QUALITY ASSURANCE -- NON-CONFORMANCE REPORT

Report No: NCR-000519

Welding	Concrete	Other	
Welding	Curing	Procedural	Bridge No: 34-0006
Joint fit-up	Coating	Other	Component: OBG Crossbeam 14 Intermediate Diaphragm
Procedural	Procedural	Description:

To:	AMERICAN BRIDGE/FLUOR, A JV 375 BURMA ROAD OAKLAND CA 95607	Date:	23-Dec-2009
Dear:	Mr. Charles Kanapicki	Contract No:	04-0120F4 04-SF-80-13.2 / 13.9
Attention:	Mr. Thomas Nilsson Project/Fabrication Manager	Job Name:	SAS Superstructure
Subject:	NCR No. ZPMC-0492	Document No:	05.03.06-000482

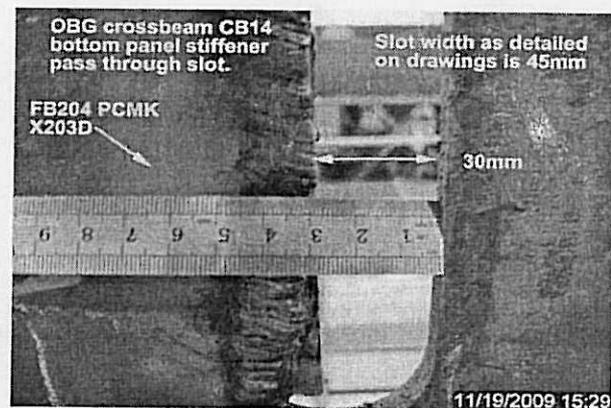
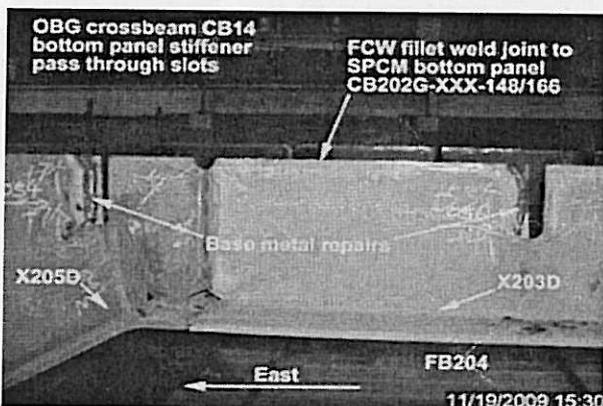
Reference Description: ZPMC performed base metal weld build-up without the Engineer's approval or an approved Critical Weld Repair procedure for CB14

This Quality Assurance (QA) inspector observed ZPMC welding personnel building up additional base metal weld to correct the dimensional/fit-up issue of the intermediate diaphragm slot holes, where the bottom panel stiffeners go through. The slots are located in the web plates of floor beam diaphragms identified as FB204 and FB205 at CB14. Piece Mark (PCMK) numbers affected are X203D, X205E, X205D and X205F at all four diaphragm locations. Weld numbers affected are as follows: CB202G-041-055, 056, 057, 058, 061 and 062; CB202G-042-053~062; CB202G-043-053~058, 061 and 062; CB202G-044-053~062; CB202G-041-051 and 052; CB202G-042-051 and 052; CB202G-043-051 and 052; CB202G-044-051 and 052. These base metal build-up were performed without the Engineer's approval or an approved critical weld repair procedure (CWR).

-AWS D1.5 2002 section 3.1.5: "Welds shall be prohibited on the work except as follows:

- (1) Base-metal repair performed in conformance with AASHTO M160/M160M (ASTM A 6/A 6M),

Draft of welding discontinuity:

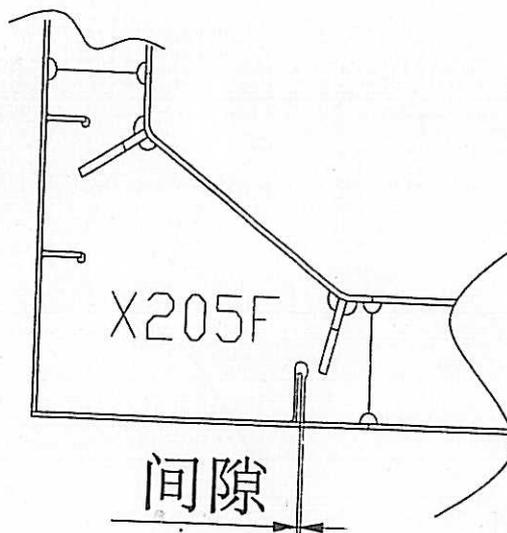
Description of welding discontinuity:

横梁CB14底板预装配发现X205D, X205E, X203D, X204B与I肋间隙偏大。经测量最小间隙4mm最大14mm。
After inspection CB14 bottom plate gap at X205D, X205E, X203D, X204B and I-ribs, minimum 4mm and maximum 14mm.

1. Grind the edge of the repair area cleanly
2. Prepare an right joint according to the approved WPS;
3. Add steel backing on one side, preheat and weld according to the approved repair WPS, perform sur fing to item X205F to make its gap with I-Rib meets the requirement;
4. Grind the repair area flush with the metal base;
5. Perform relevant NDT inspection to repair area according to the working drawing.

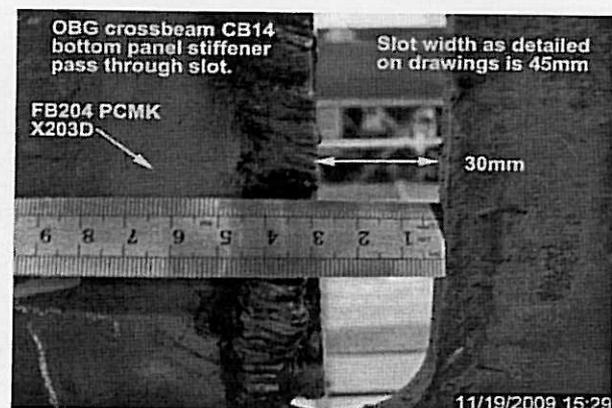
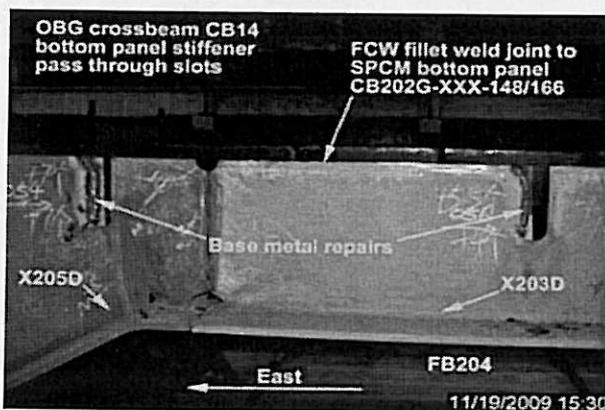
Reference Description: ZPMC performed base metal weld build-up without the Engineer's approval or an approved Critical Weld Repair procedure for CB14

This Quality Assurance (QA) inspector observed ZPMC welding personnel building up additional base metal weld to correct the dimensional/fit-up issue of the intermediate diaphragm slot holes, where the bottom panel stiffeners go through. The slots are located in the web plates of floor beam diaphragms identified as FB204 and FB205 at CB14. Piece Mark (PCMK) numbers affected are X203D, X205E, X205D and X205F at all four diaphragm locations. Weld numbers affected are as follows: CB202G-041-055, 056, 057, 058, 061 and 062; CB202G-042-053~062; CB202G-043-053~058, 061 and 062; CB202G-044-053~062; CB202G-041-051 and 052; CB202G-042-051 and 052; CB202G-043-051 and 052; CB202G-044-051 and 052. These base metal build-up were performed without the Engineer's approval or an approved critical weld repair procedure (CWR).

-AWS D1.5 2002 section 3.1.5: "Welds shall be prohibited on the work except as follows:

- (1) Base-metal repair performed in conformance with AASHTO M160/M160M (ASTM A 6/A 6M),

Draft of welding discontinuity:

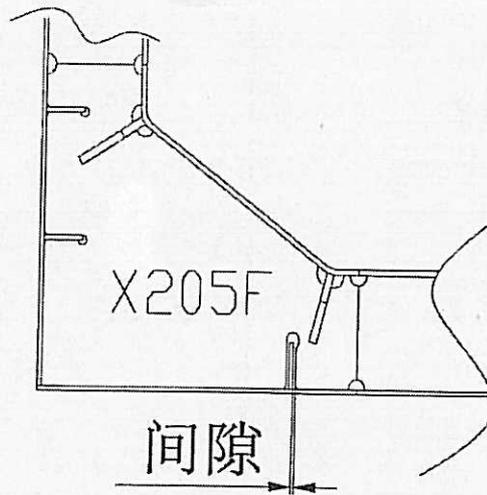
Description of welding discontinuity:

After inspection CB14 bottom plate, gap was found at X205F and I-ribs, minimum 4mm and maximum 14mm.

1. Grind the edge of the repair area cleanly
2. Prepare an right joint according to the approved WPS;
3. Add steel backing on one side, preheat and weld according to the approved repair WPS, perform sur fing to item X205F to make its gap with I-Rib meets the requirement;
4. Grind the repair area flush with the metal base;
5. Perform relevant NDT inspection to repair area according to the working drawing.
